In the matter of: Plan Change 5 to the Hamilton City Plan

In the matter of: Submissions and Further Submissions by Kāinga Ora – Homes and Communities

Statement of evidence of Susannah Vrena Tait

Dated: 16 September 2022

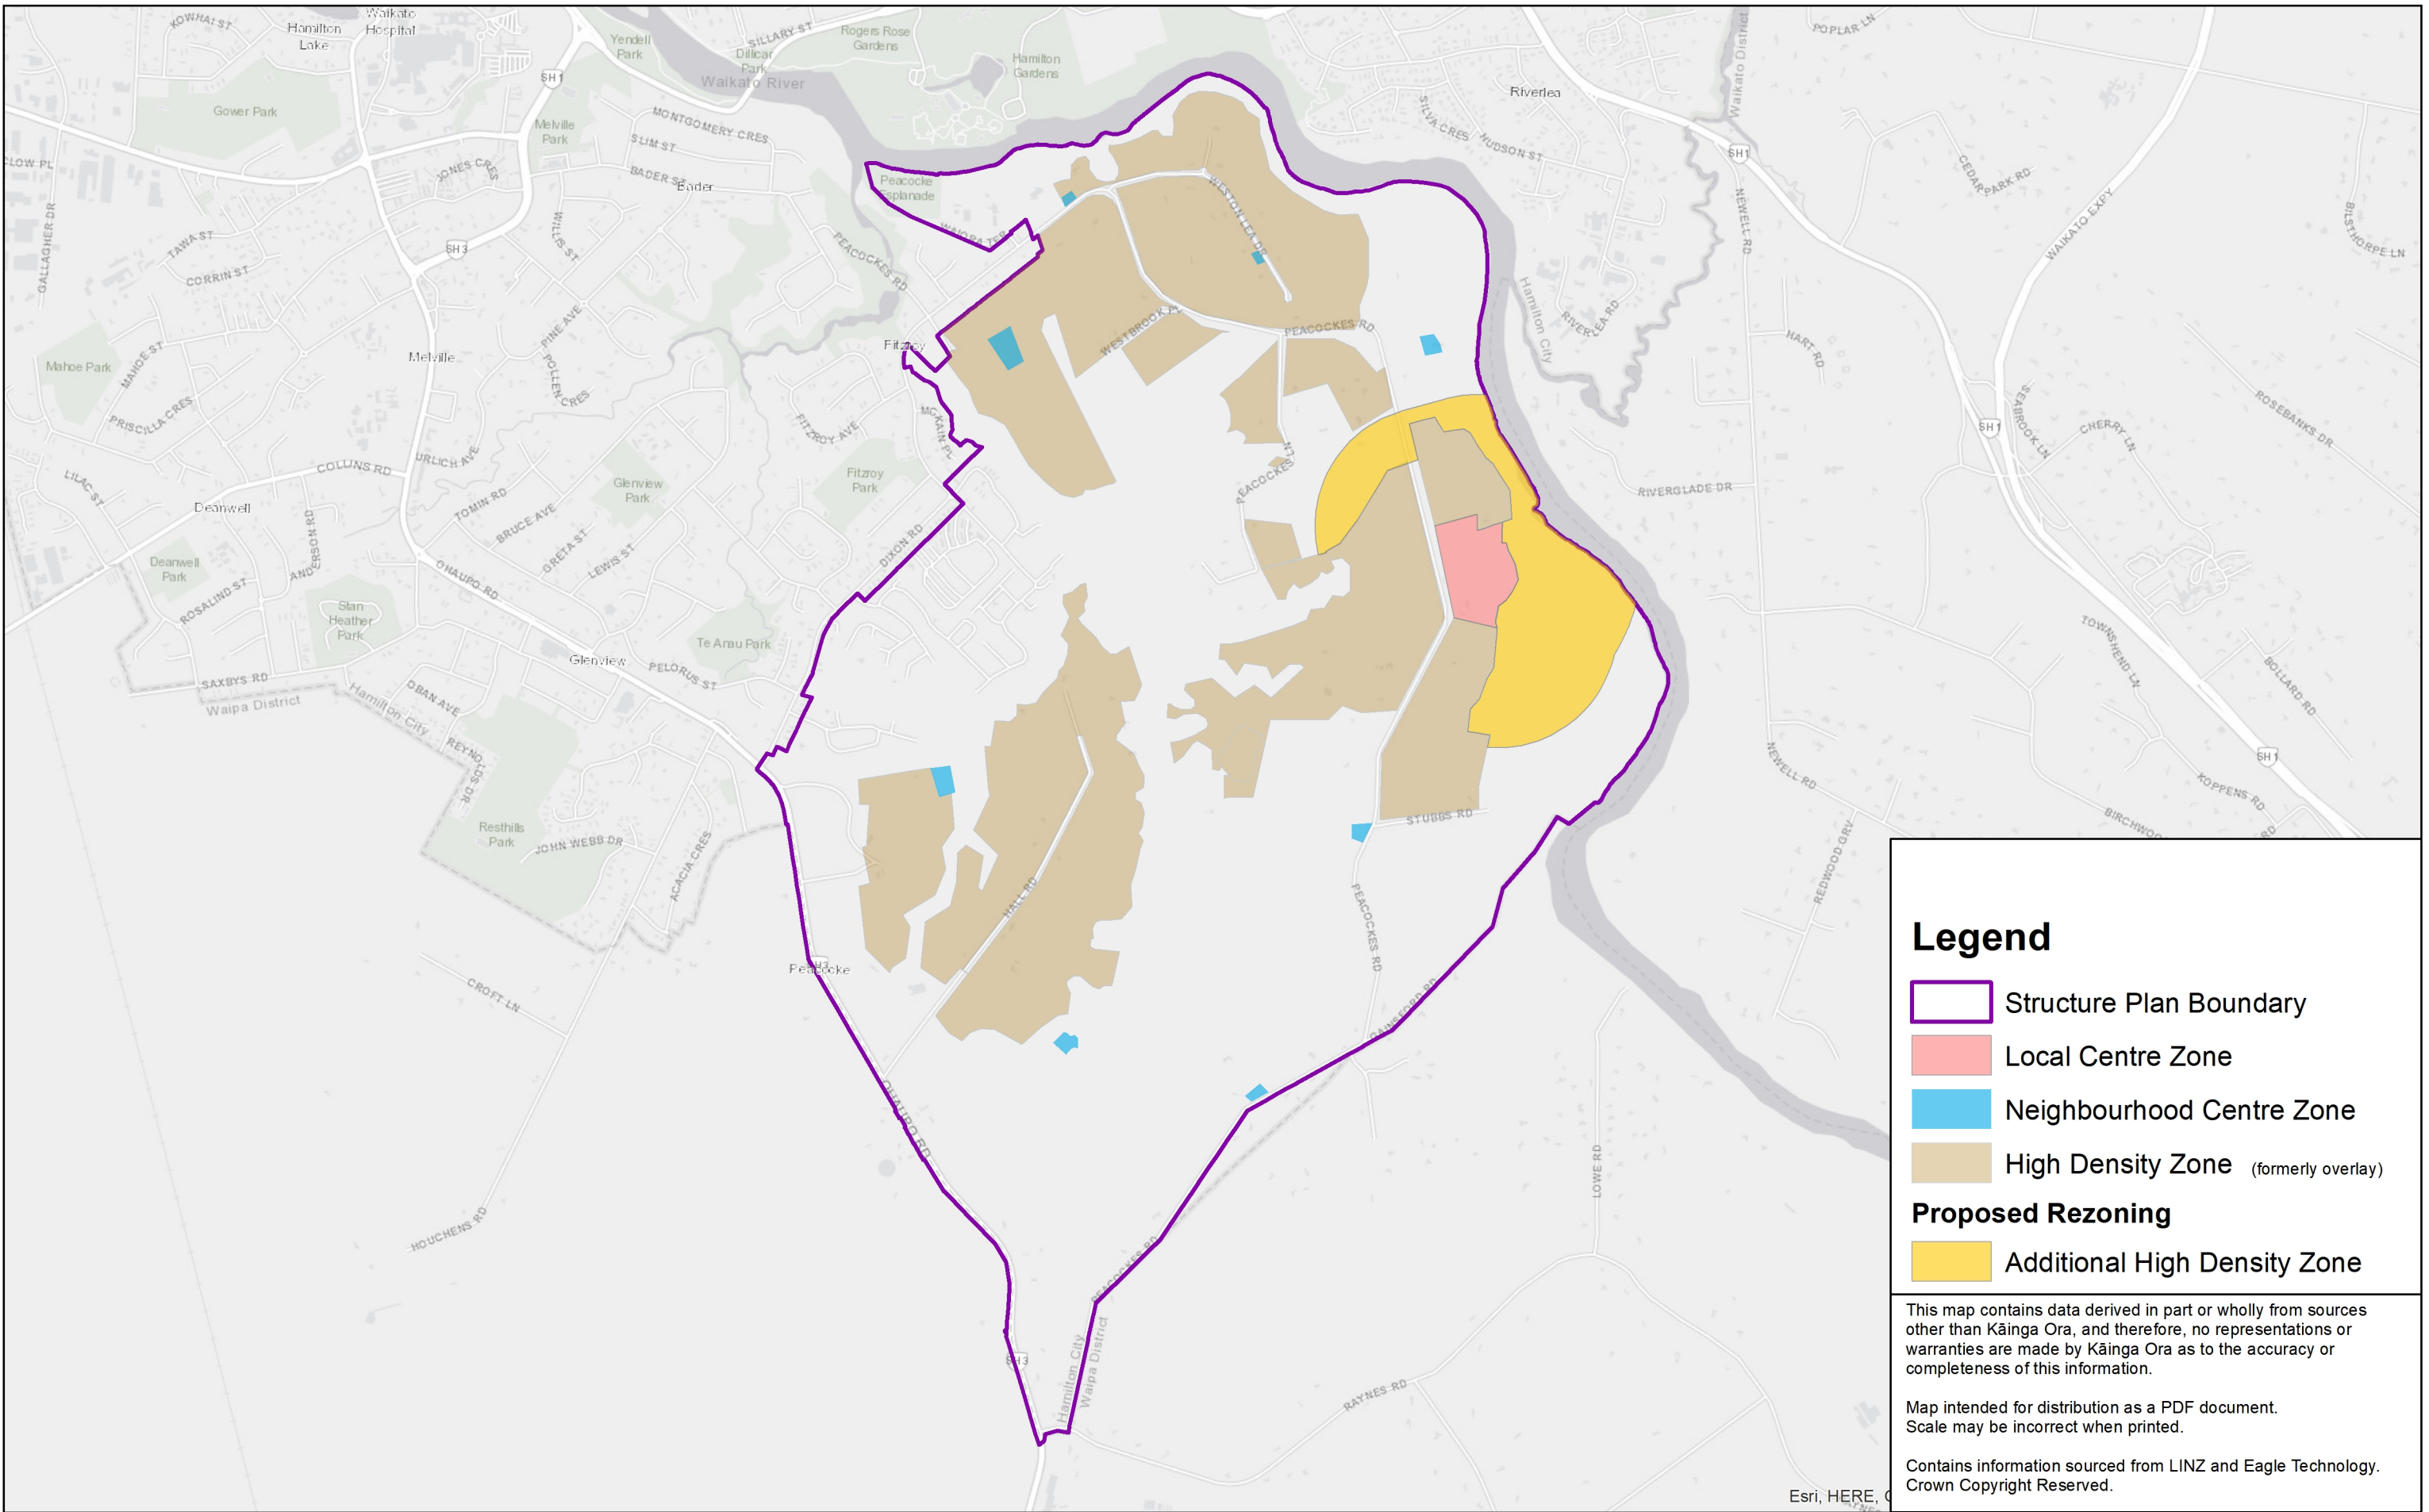
- 65 In submissions⁴¹, Kāinga Ora opposed the HDO and submitted that a more effective tool would be the use of a High Density Zone (HDZ). In addition, Kāinga Ora sought that the extent of the HDZ be larger than shown in the HDO. A copy of the map showing the HDZ (provided with Kāinga Ora original submission) is included in **Appendix E**.

APPENDIX F

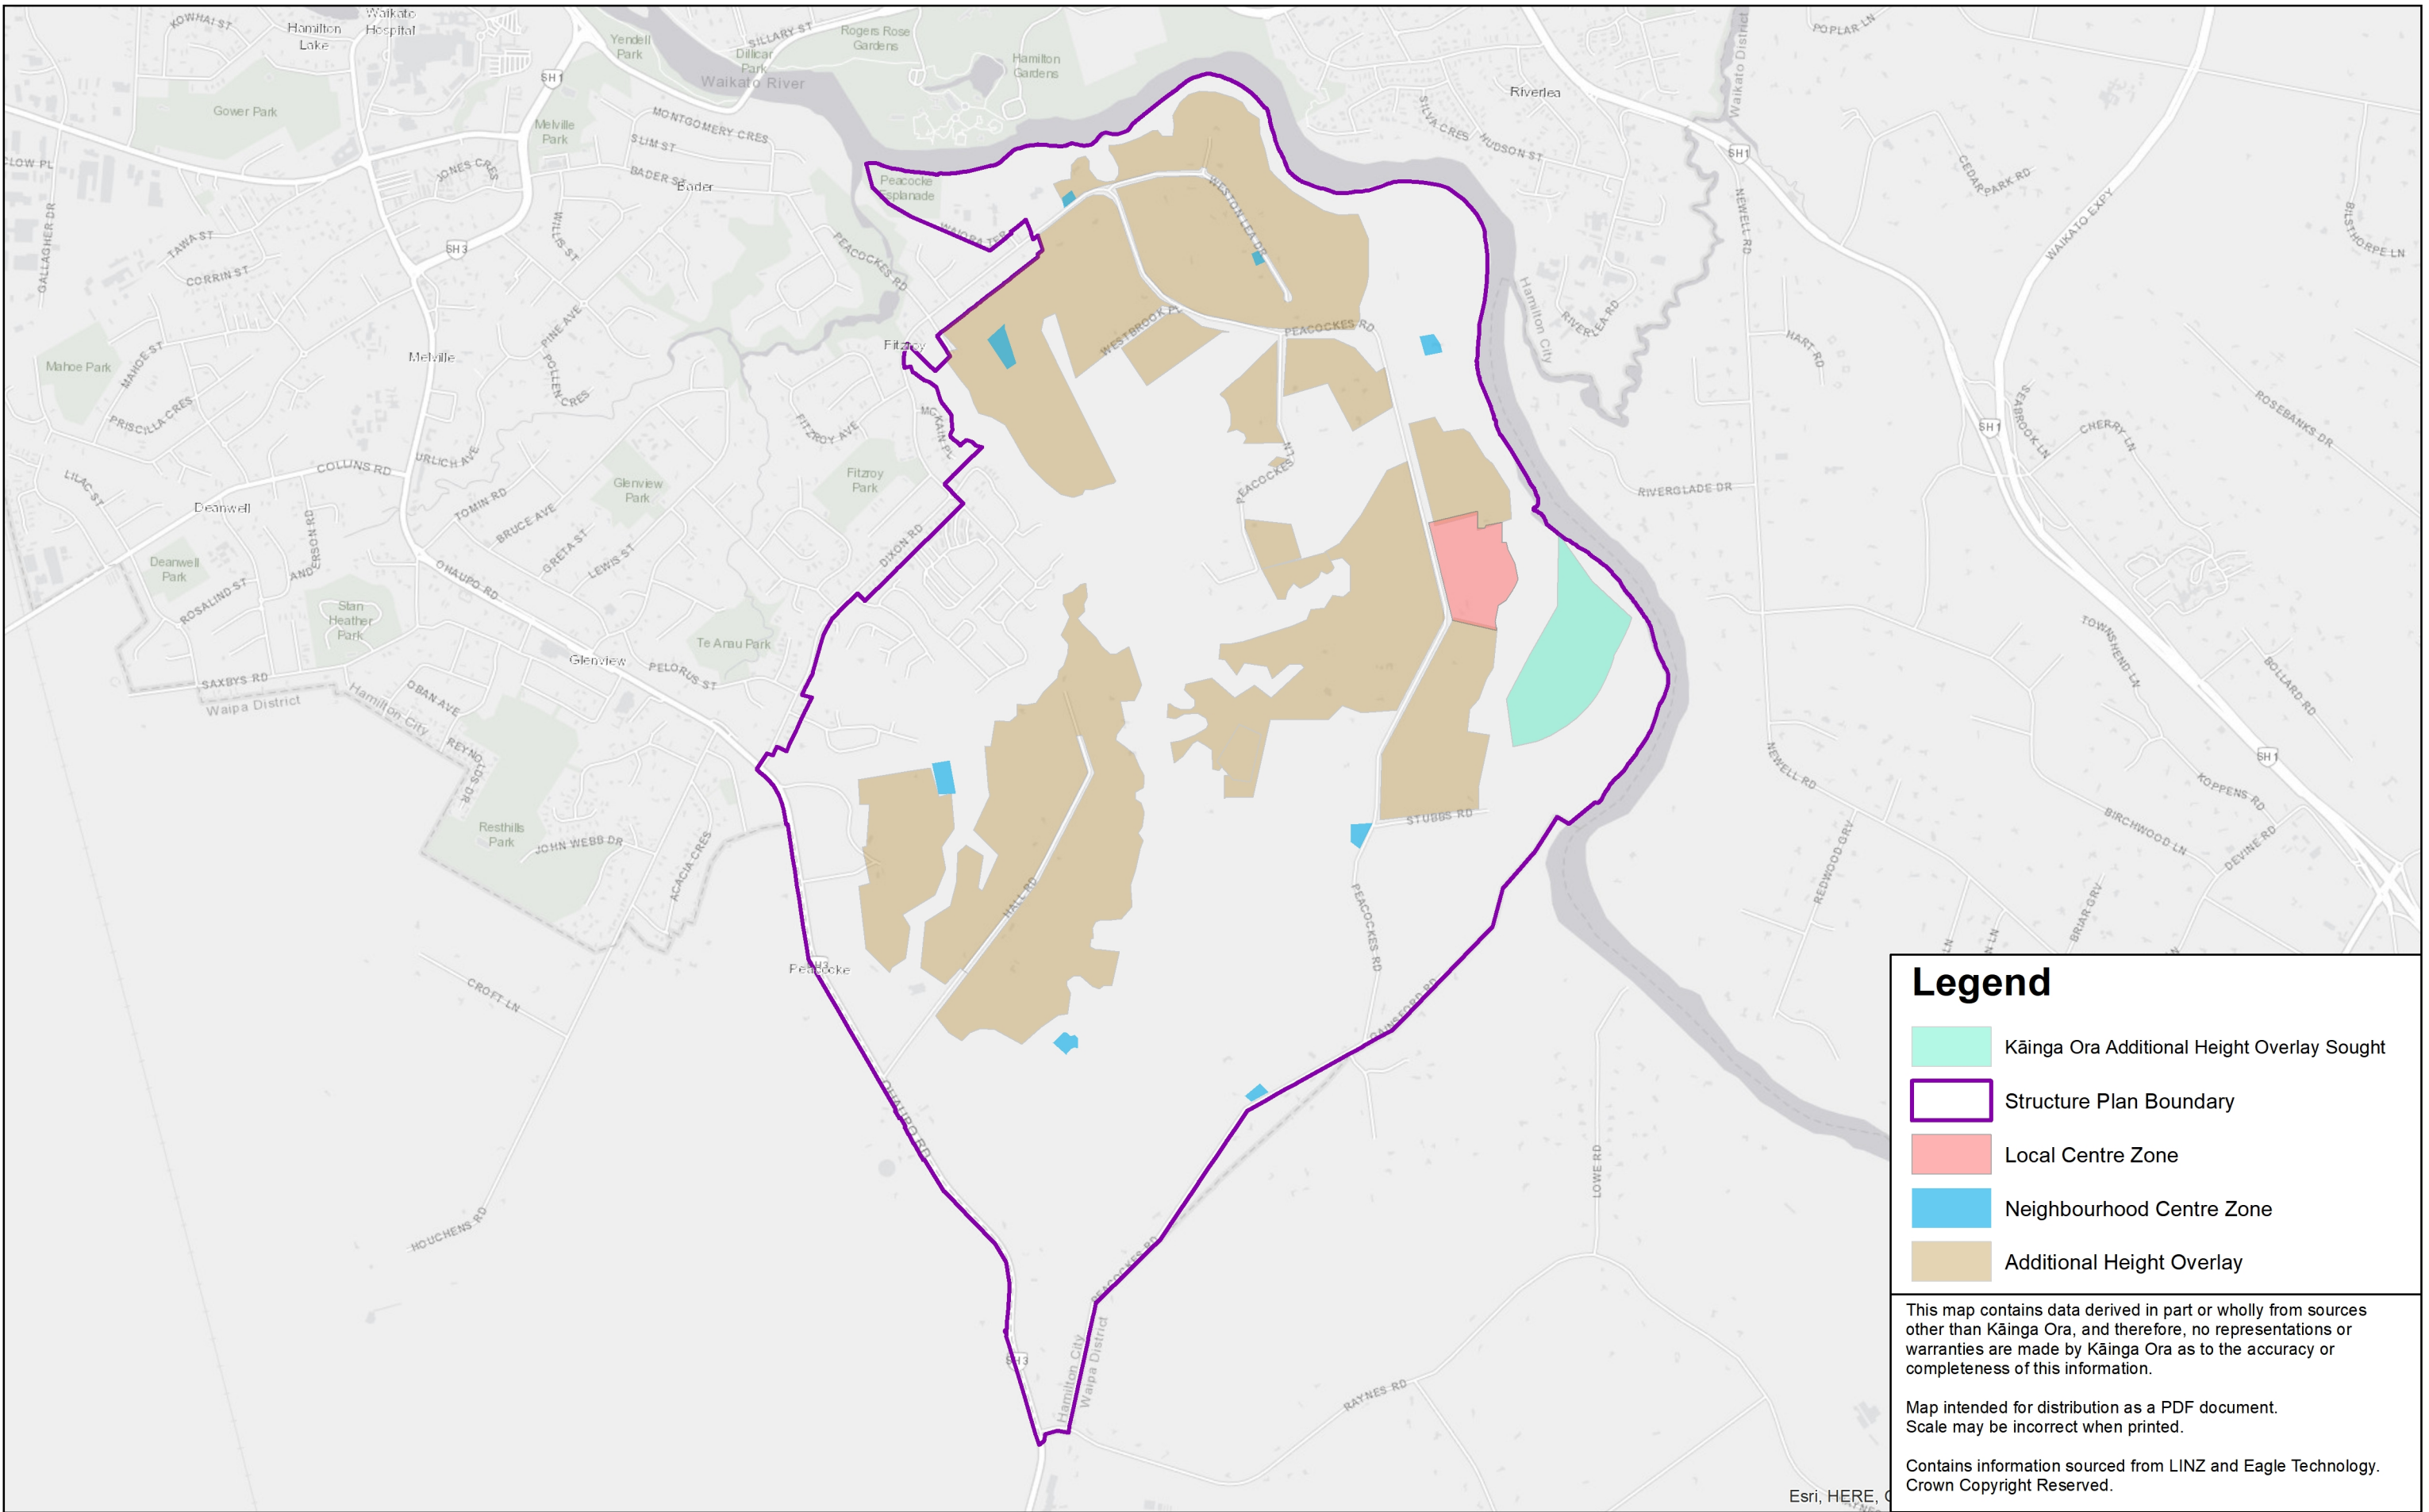
- 69 These comments are acknowledged, and Kāinga Ora has prepared a map (**Appendix F**) revising the extent of the IHO to take into account the topographical and other constraints identified by the reporting officer. The revised map still includes the area to the southeast of the LCZ across the gully.

- 70 I support this modest extension of the IHO and consider it appropriate. This area is not topographically constrained, will be well connected by two bridges to the west, is a walkable distance to the LCZ and public transport and I consider it to be a desirable location in close proximity to the Waikato River. On this basis, this location would give effect to the NPSUD (specifically Objectives 3a, 3b, 3c and 8a and Policies 1c, 1e, and 3d), Policy 6.1 of the Waikato Regional Policy Statement (specifically Principles (c), (e) and (i) in Schedule 6A) and proposed MRZ-PREC1-PSP:O4 and proposed MRZ-PREC1-PSP:P1.
